# Summary of John and Yan's work on the optimized shed for the R30 inverted insulators

John's design of Yan's optimized shed for R30 inverted insulator

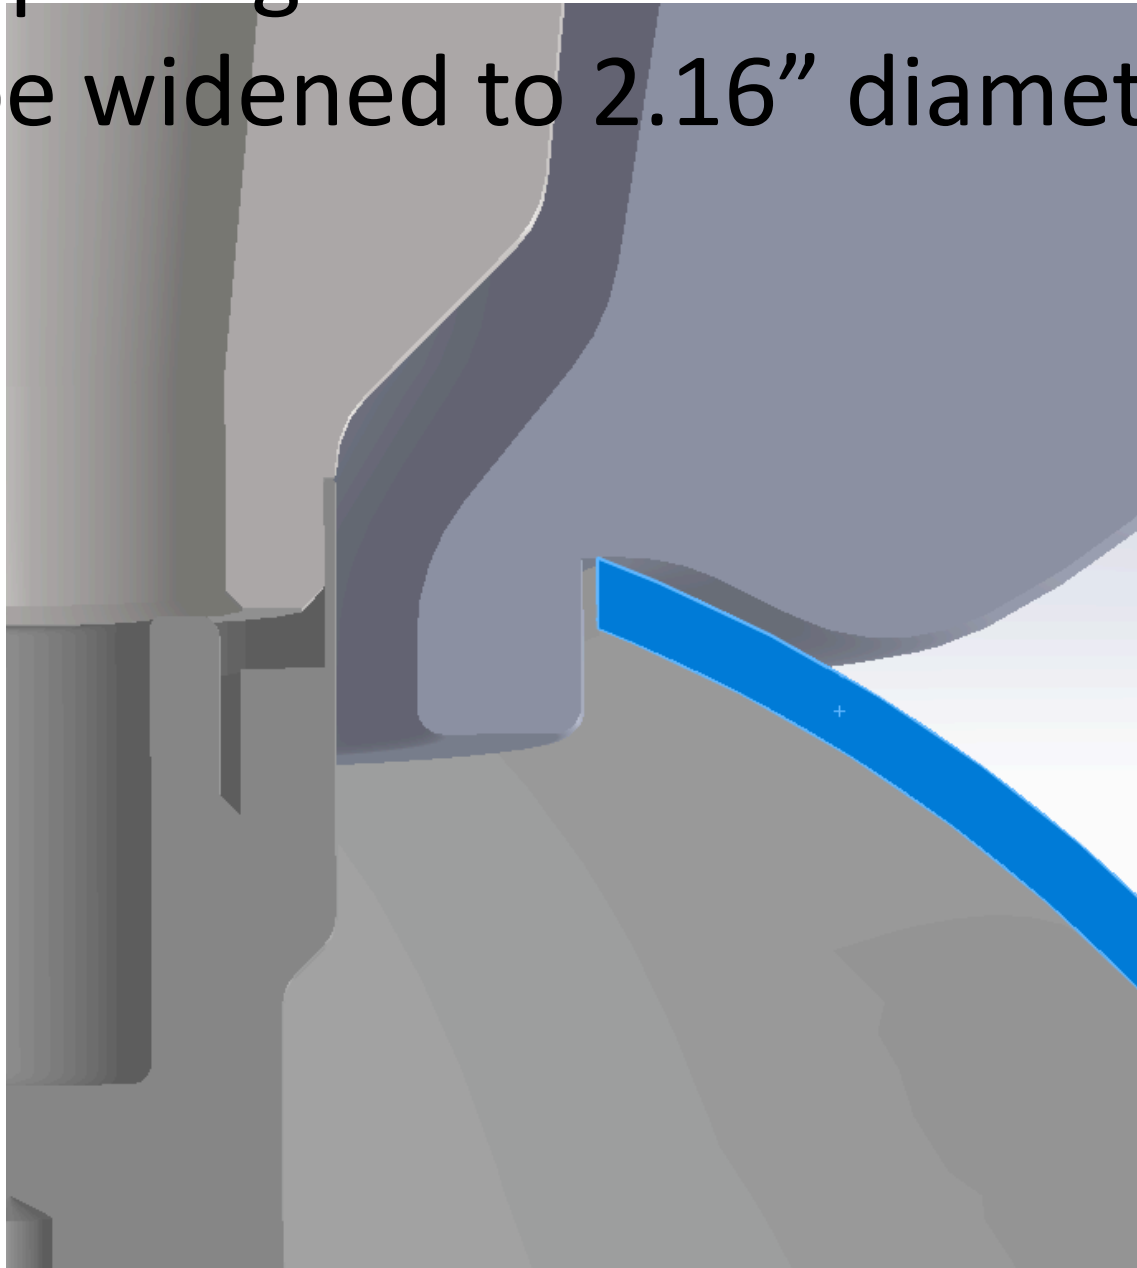
John: In your original document you would draw a circle of 1" radius at position X=4.02cm and Y= 9.642cm. This is the fillet that tapers your "C" curve inward to the mount. You can see that at 180 degree position it transitions to a flat that extends to the ball hole. It is also worth noting that the ball hole has been enlarged to a 2.75 cm opening, so the top of the hole is along this flat.I need you (Yan) to confirm that this does not change your fields.

The opening of the ball cathode has to be widened to 2.16" diameter

Three holes at 120 deg to hold it

Hog out option to reduce weight, Yan's preliminary simulations show no major changes in field, but Yan will make graphs of potential along ceramic
